PROJECT: 585

Re: Certification Submittal for Final Building Certificate of Occupancy for
Stewart & Stevenson Building, [J-10 / D042]
6565 Hanover Road NW
Architect's Stamp Dated 07/18/08

RE: S & S RV, 6565 Hanover Rd. NW, (J-10/D042)
Request for Permanent Certification of Occupancy
Engineers Stamp dated 09/24/2007
Engineers Certification dated 07/08/2008

**Re: S & S RV, Hanover Rd NW, Preliminary Plat
Engineer's Stamp dated 3-09-06 (J10-D42)**

FIGURE 7

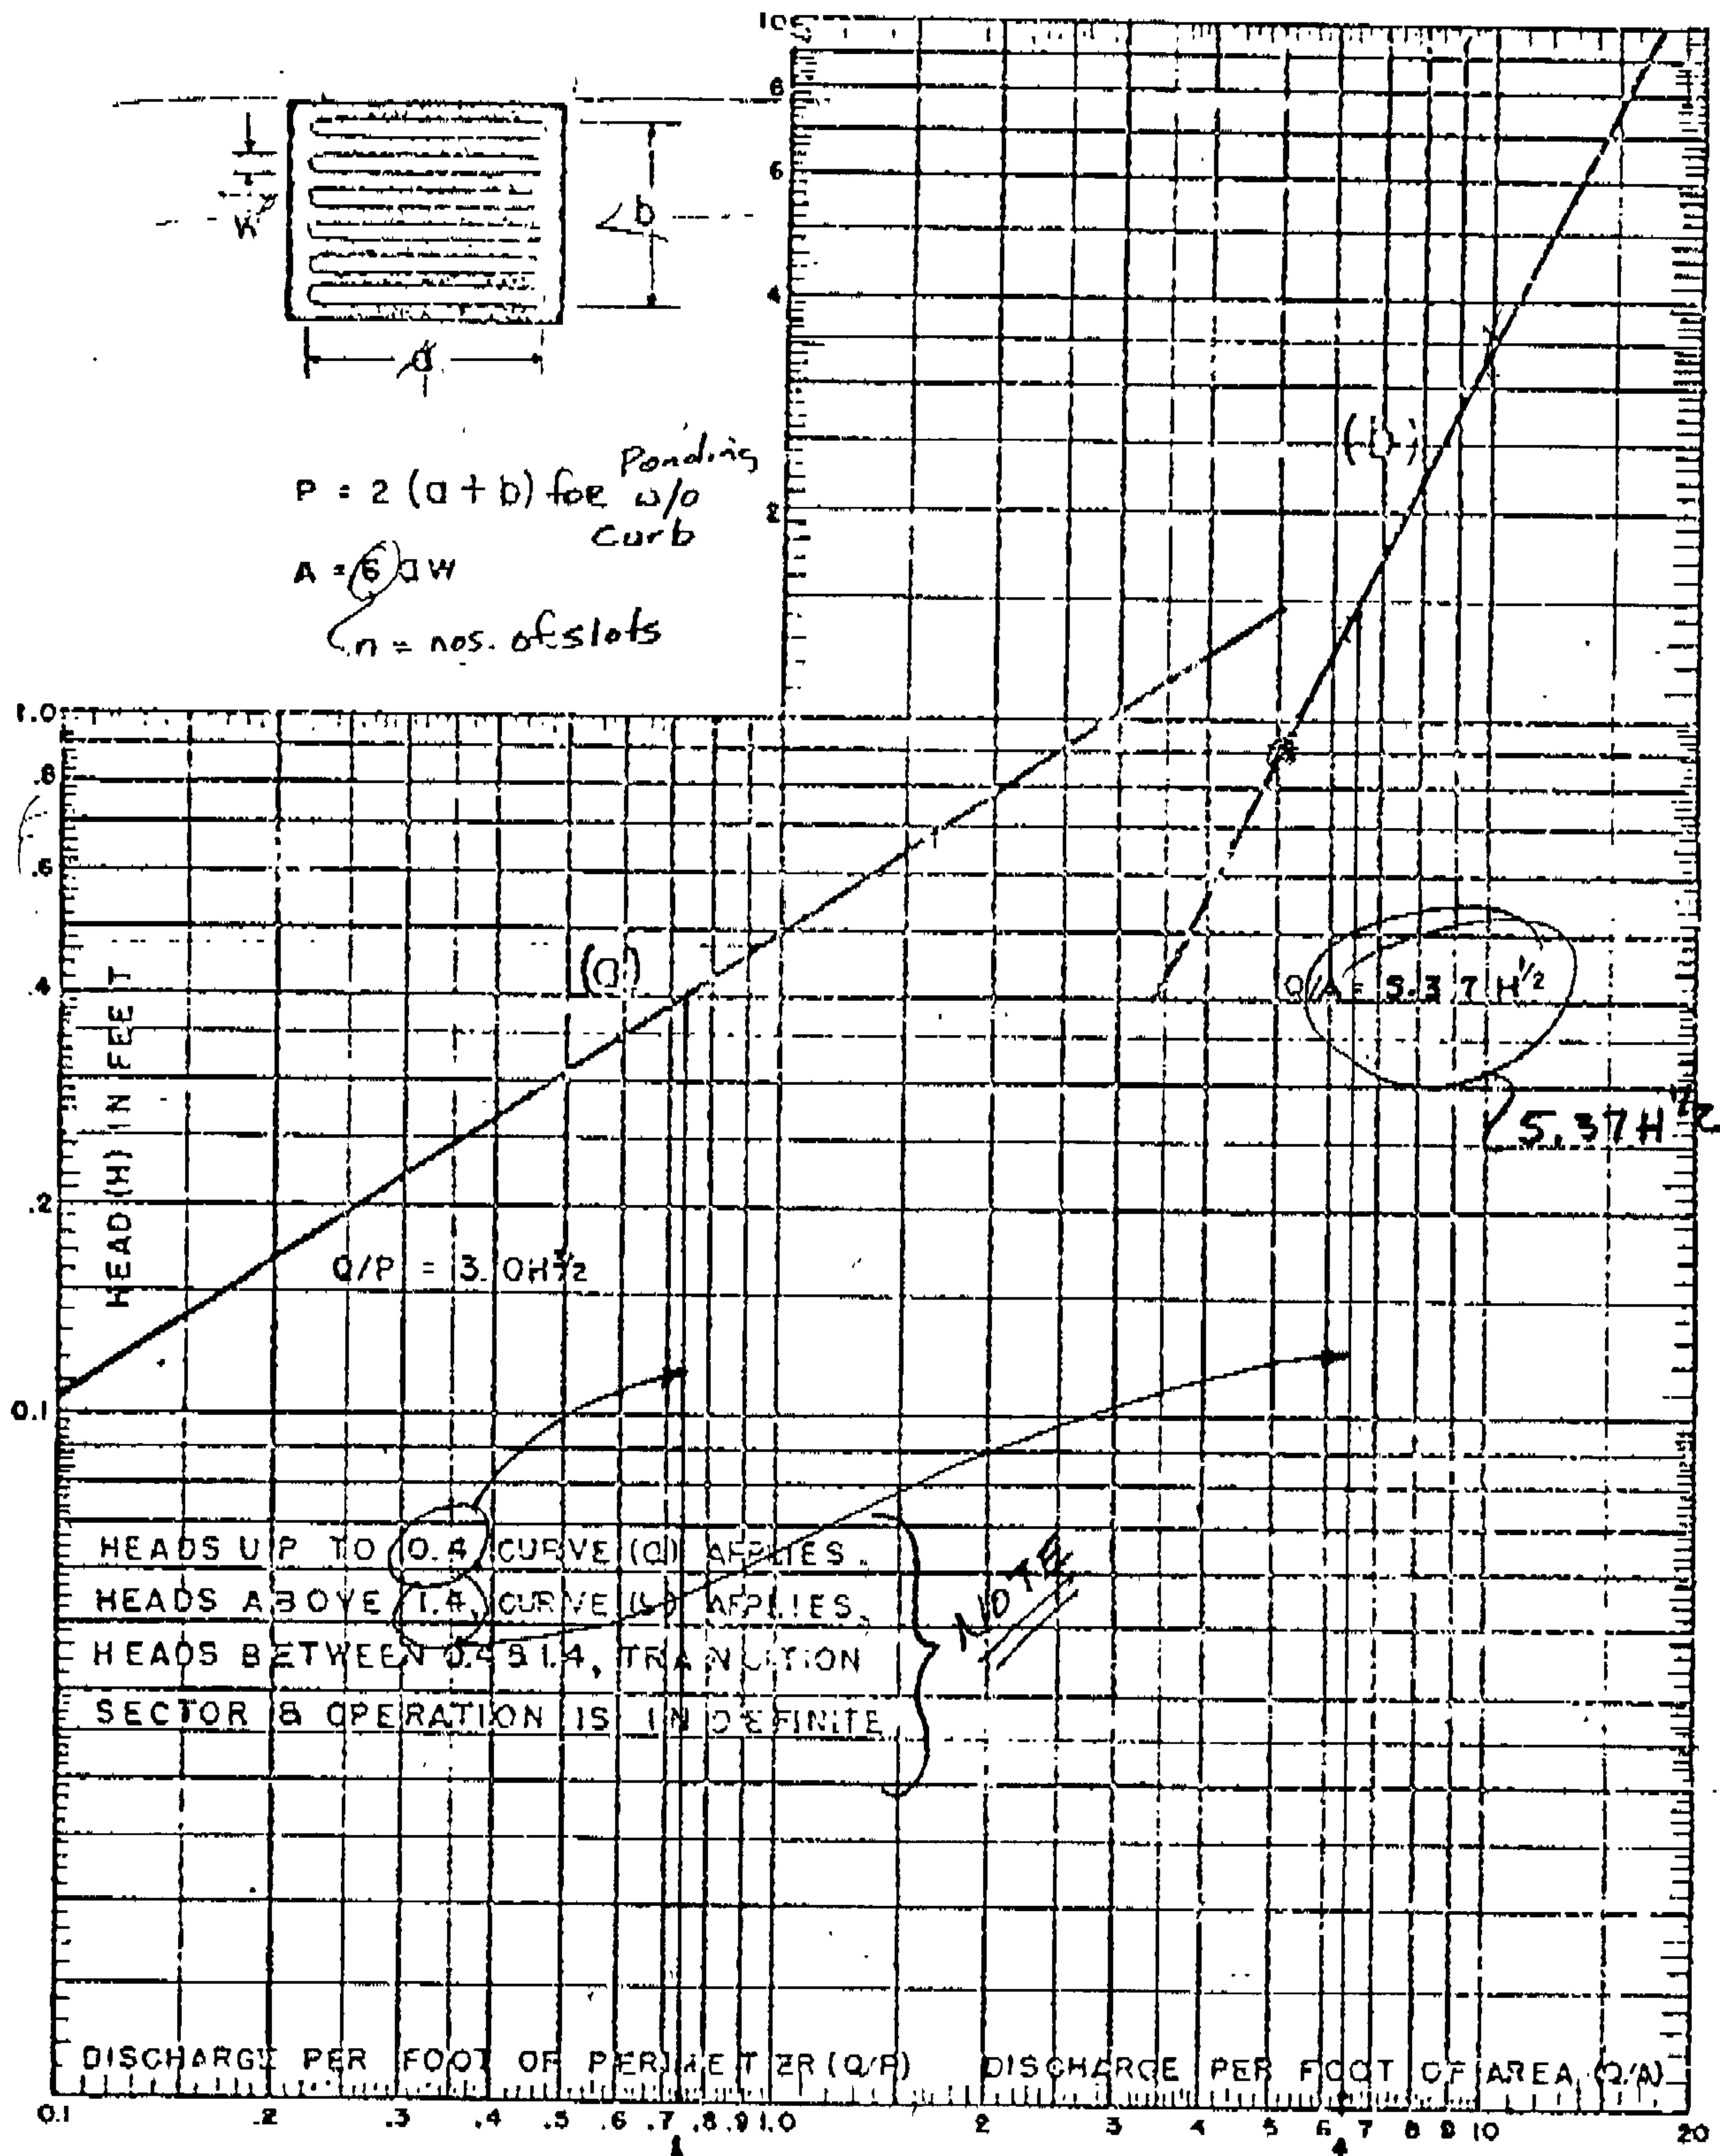
Capacity of Sump Inlet, Fig. 7, \neq CoA # 2220.

where: $h = 0.4'$ $\Rightarrow (.74 \times 17.5)$ (point of double) = 12.95 cfs

Then, where: $h = 1.4'$ $\Rightarrow 2(.64 \times 4.5)$ double grate Area of Sump = 57.6 cfs

\therefore 32.2 cfs, using $h = 0.83'$ provided

The above is the analysis of a Double 'D' Inlet in a Low Spot (Sump) with 10" (0.83') of Head and is conservative by not using curb opening

CALCULATIONS

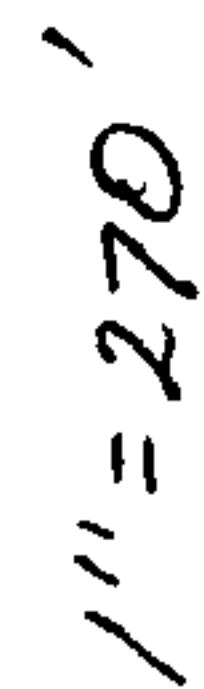
- OFF-SITE BASIN #1 - I-40 Depressed Median + Inside Driving Lane + 12' Asp. Shldr.

$$130' \times 840' = 2.5 \text{ AC} \quad \text{where: Land Treatment is } 60\% \text{ B; } 40\% \text{ D}$$

$$\therefore Q_{100} = 2.5 \text{ AC} \times 2.9 \text{ cfs/ac.} \\ = \underline{7.2 \text{ cfs}} \quad \text{Draining to Exist. 4'x5' SHD Area Drain, See Plan}$$

Note - This runoff Ponds w/in the Exist. 2-3'x6' CBC and Ponds A portion of flow @ the outlet (Note the depression contour).

- OFF-SITE Basin #2 Eastbound OUTER LANES OF I-40 + TR. 271 + 272 and Fill slope of I-40 OPP. " "

$$\text{CDD\#2 Area} = 1.03 + 1.05 \text{ AC.} = 2.08 \text{ AC.}$$

$$Q_{100} = 1.03 \times 2.7 \text{ cfs/ac.} + 1.05 \times 3.7 \text{ cfs/ac.}$$

$$= \underline{6.7 \text{ cfs}} \quad \text{Estim. Runoff in Hanover @ SW Cor. of Site (Developed)}$$

- Per DPM, "Street Hydraulics", Ch. 22.3
2.6 use 0.83' street depth MAX.

✓ Cap. of Double 'C' Inlet @ -1% & -0.5% (Controls)

@ d = 0.83', 0.5% ; Read 15 cfs OK

@ d = 0.67', 0.5% ; " 10 cfs

∴ Add 1- double 'C', See plan.

✓ EXIST. Modified (double 'A' Inlet "debris catcher" (14' W. Curb opening)

@ d = 0.87' (Low-point) Read 13 cfs ... OK
